[Docket No. FAA-2014-0337; Directorate Identifier 2013-SW-029-AD]

#### Airworthiness Directives; Various Restricted Category Helicopters

**ACTION:** Notice of proposed rulemaking (NPRM).

**SUMMARY:** We propose to supersede airworthiness directive (AD) 2012-14-11 for Arrow Falcon Exporters, Inc. (AFE), Rotorcraft Development Corporation (RDC), and San Joaquin Helicopters (SJH) Model OH-58A, OH-58A+, and OH-58C helicopters. AD 2012-14-11 currently requires inspecting the main rotor mast (mast) for a crack. Since we issued AD 2012-14-11, we have determined that the area of the mast requiring inspection should be expanded and repetitive inspections of the mast should be accomplished. This proposed AD would expand the

Figure 1 to Paragraph (f)

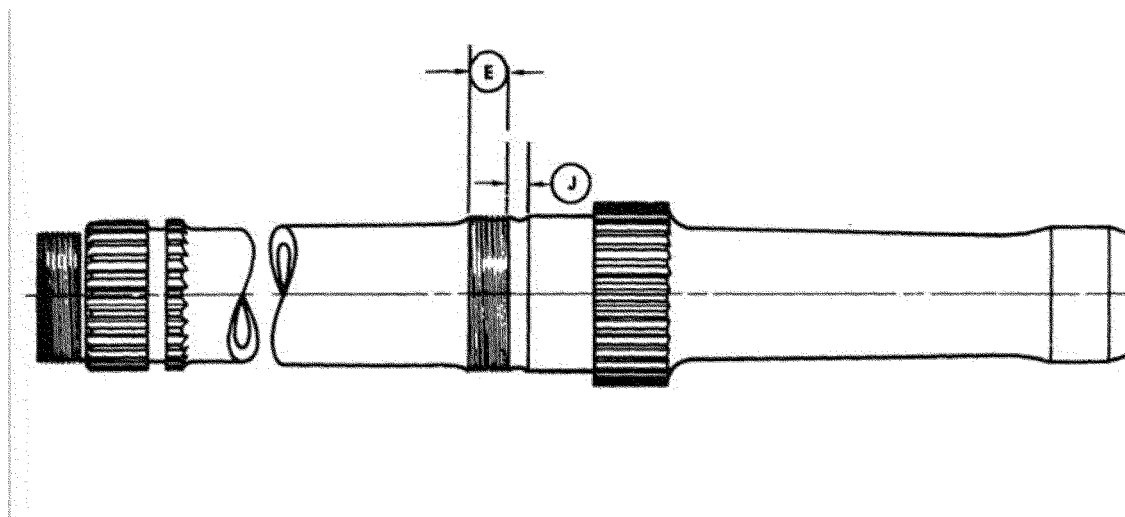
The National Transportation Safety Board (NTSB) commented in support of the required inspection of the threaded area of the mast for a crack, pitting, or corrosion, but requested that the area adjacent to the threaded area (identified in AD 2012–14–11 as “area J”) be added

to the visual inspection requirements of the proposed AD. The NTSB states that a prior accident investigation revealed the mast had fractured in this section. We agree with this comment. Although AD 2012–14–11 does contain a requirement for magnetic particle inspecting the entire mast for a crack, we have included the expanded area in the visual inspection requirements in the proposed AD.

(i) Remove any surface rust with a wire brush or steel wool and, using a 10X or higher power magnifying glass, inspect the areas of the mast as shown in area E and area J of Figure 1 to Paragraph (f) of this AD for pitting, corrosion, or a crack.

(2) If there is a crack, pitting, or corrosion, before further flight, replace the mast with an airworthy mast.
